**GENERAL**

The following changes are effective immediately and shall be incorporated in the Contract Documents.

Project Name: **PRESCOTT RECREATION COMPLEX**  
 Drawing No.: **D-2**

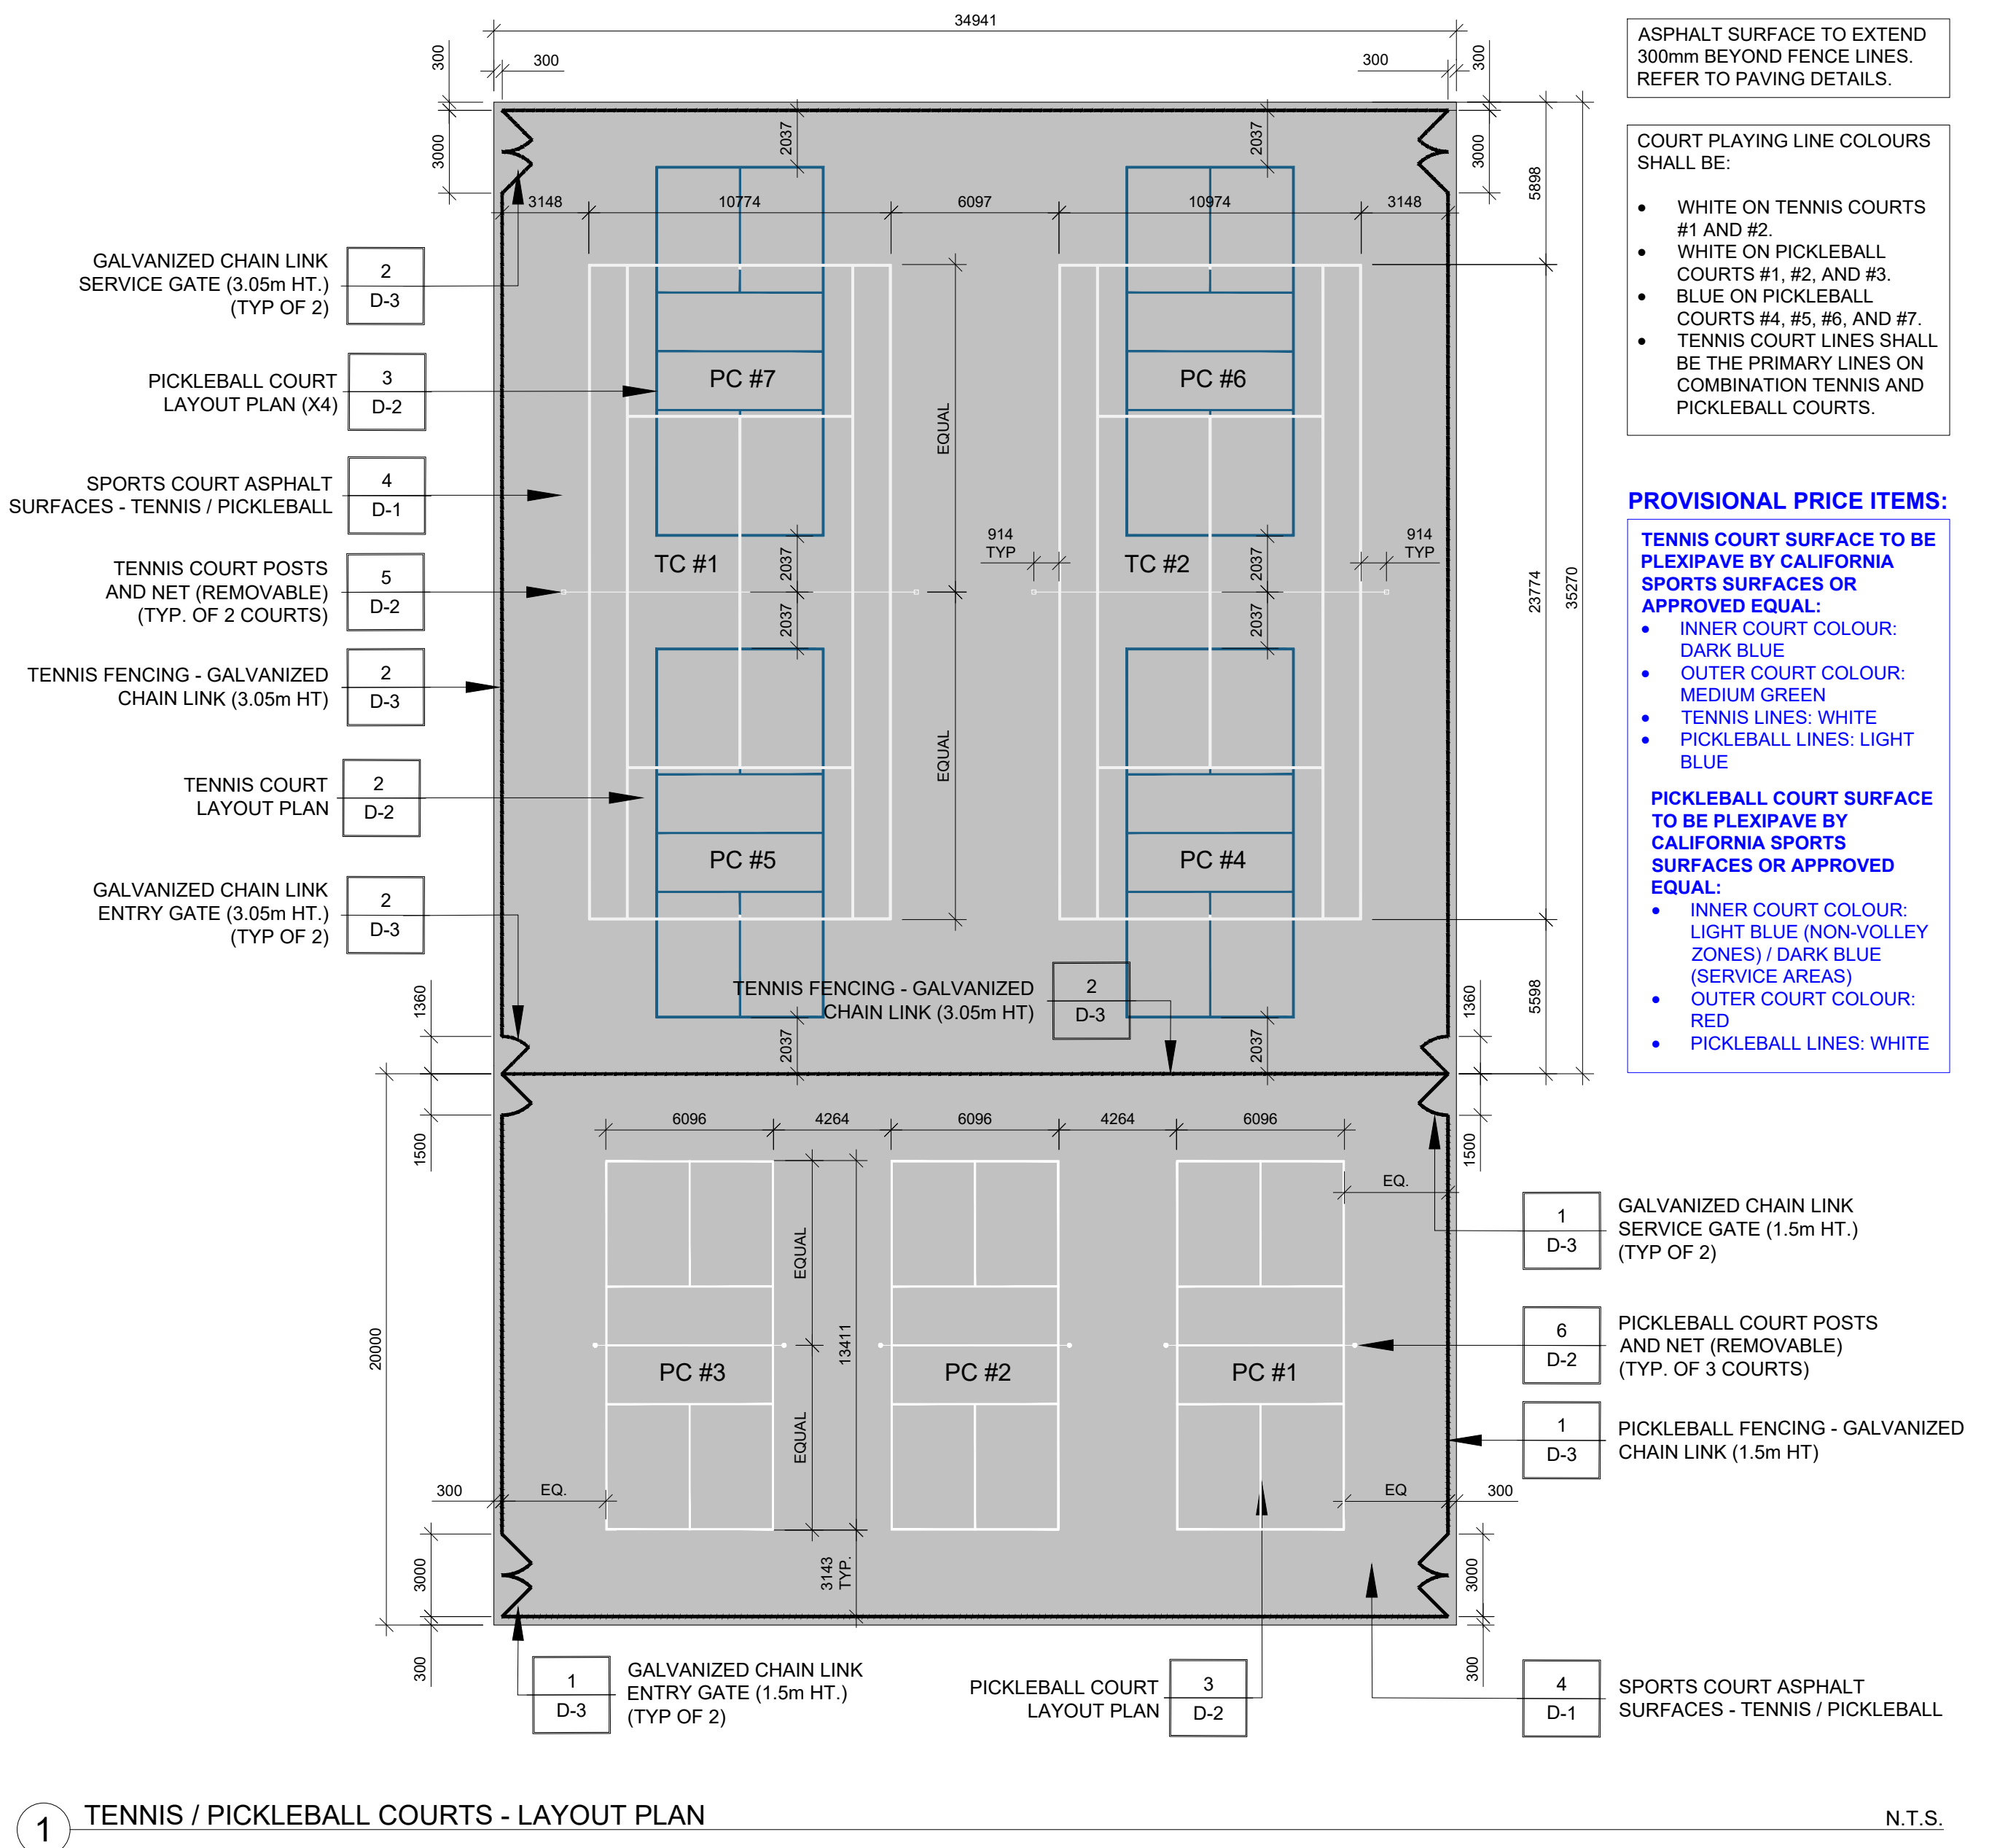
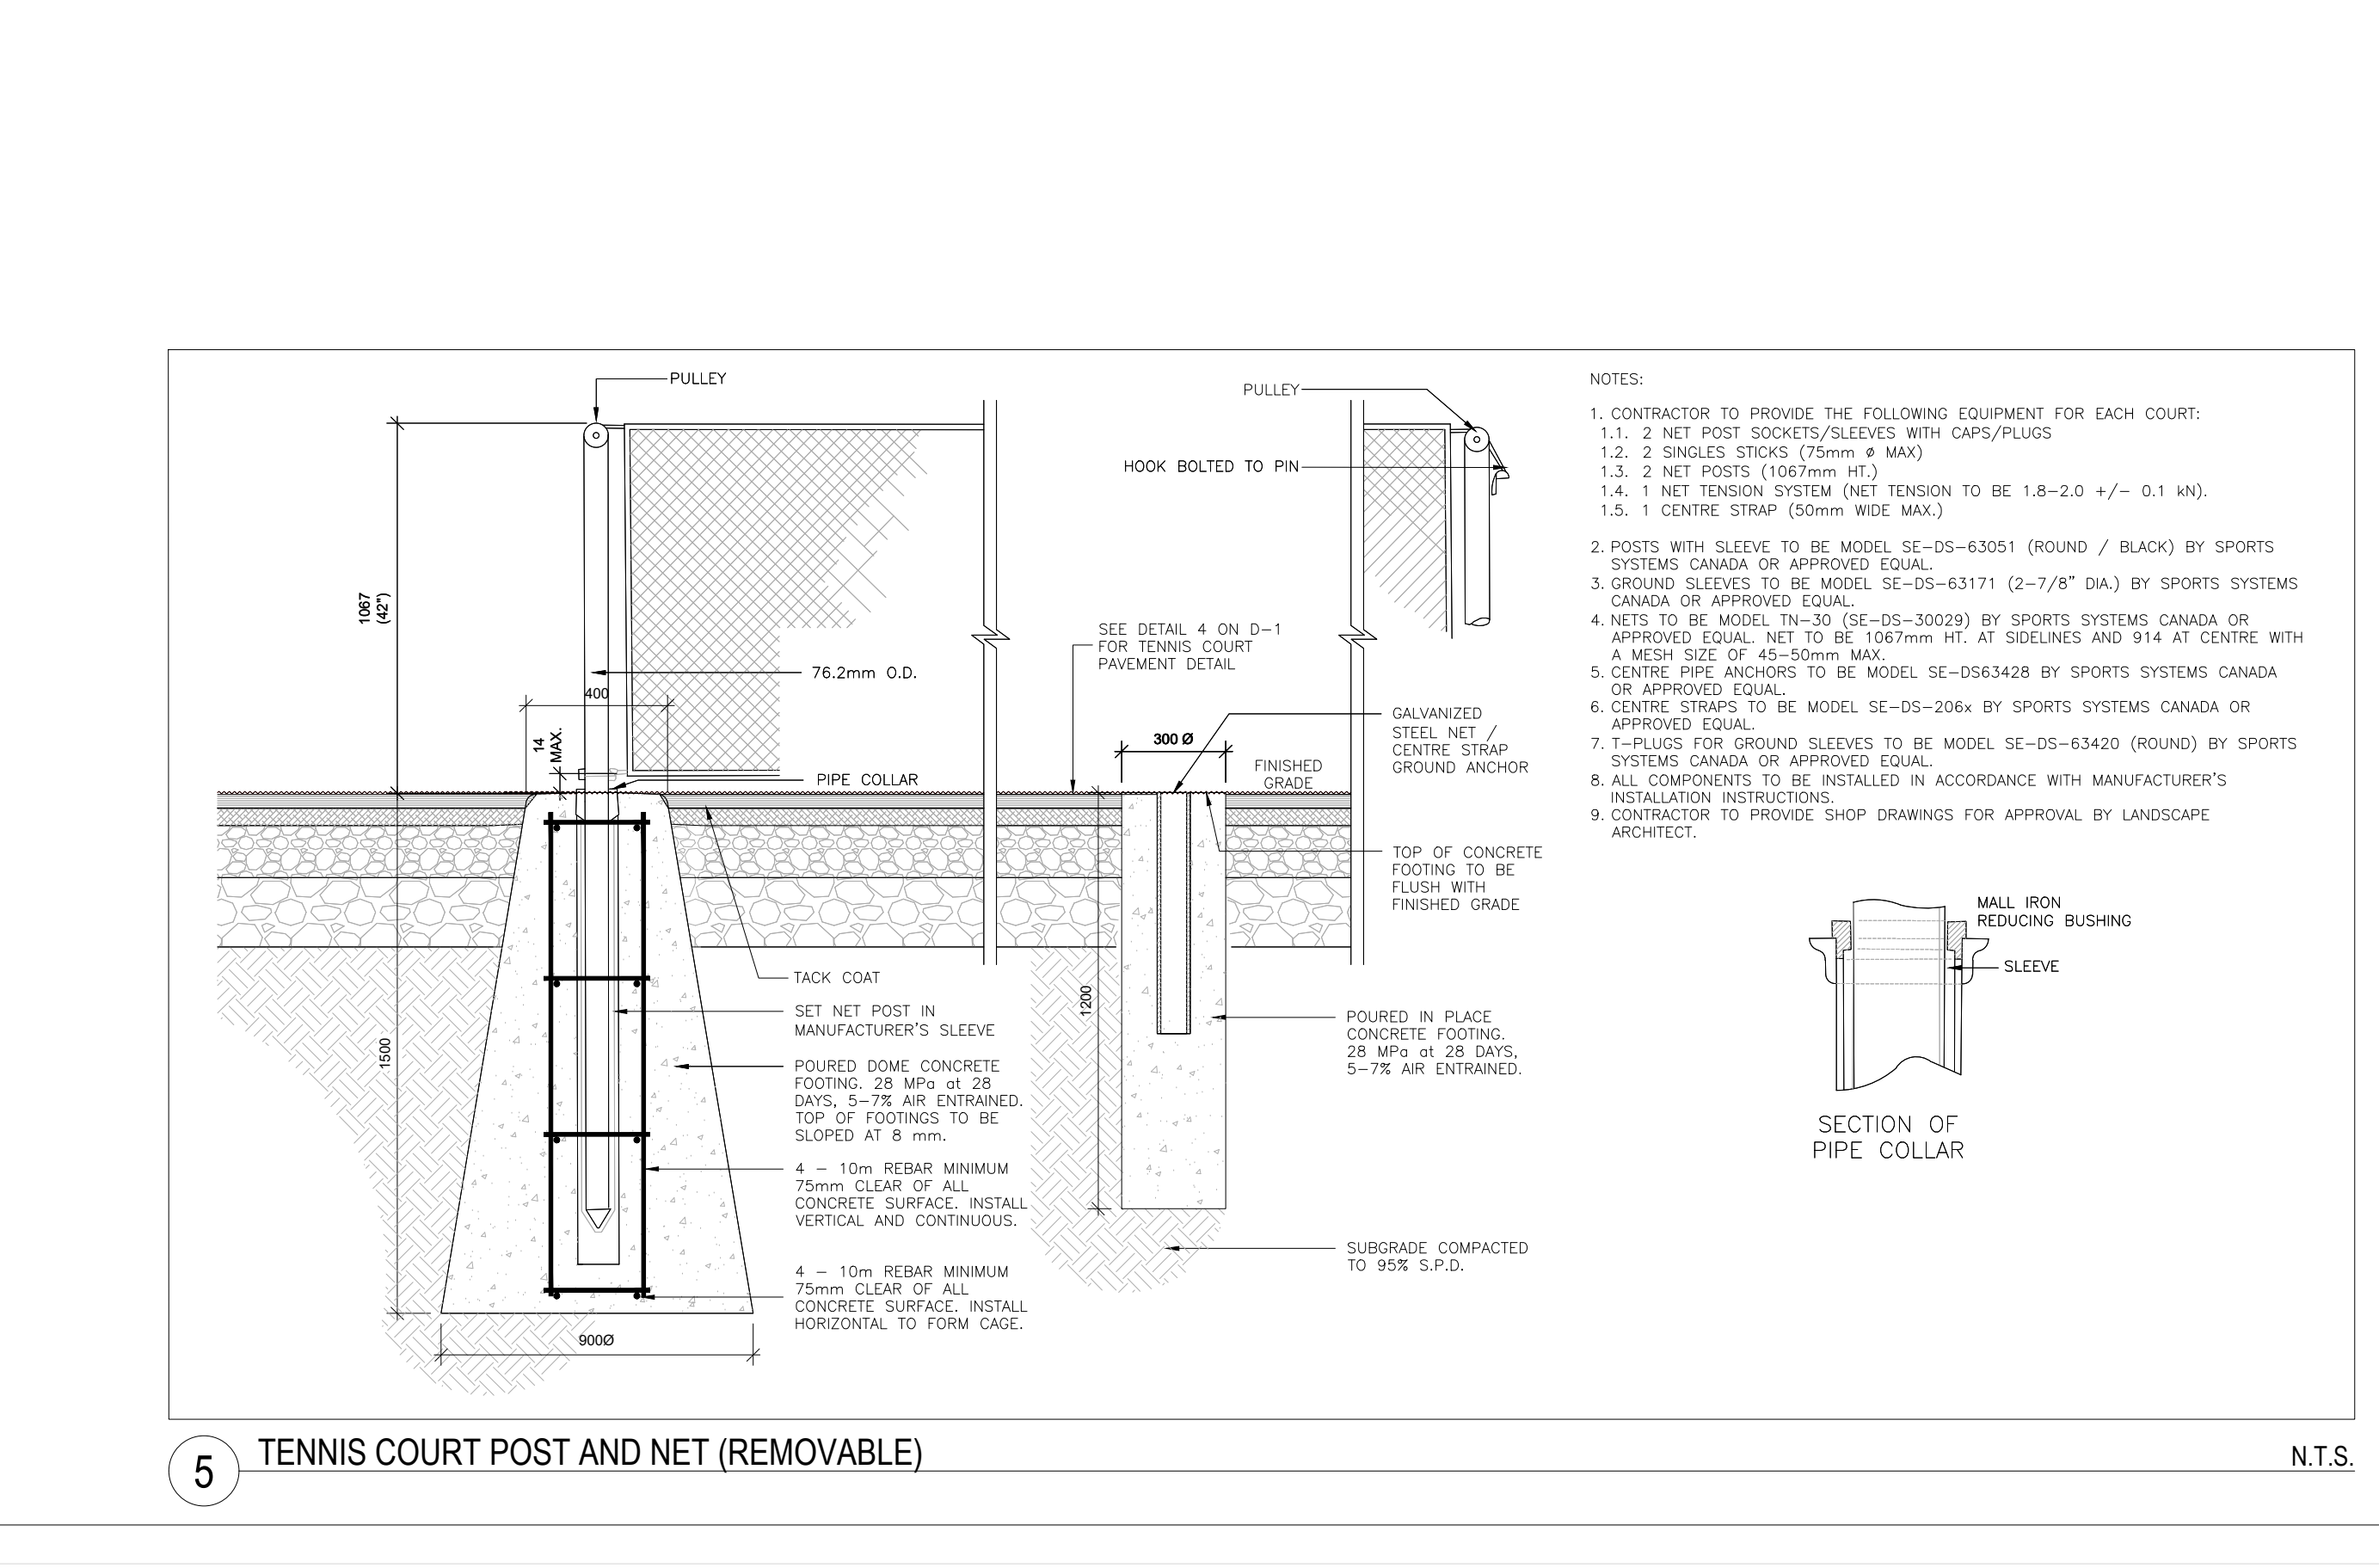
1. Drawing C1.1 – Site Servicing Plan
  1. Change Label on PECB2 to read:
    - T/G – 92.22m
    - INV. N – 91.34m
    - INV. S – 91.33m
    - INV. W – 91.53m
2. Drawing D-2 – Sports Court Details
  1. Modify detail 1 – Tennis/Pickleball Courts – Layout Plan as per attached updated drawing D-2.
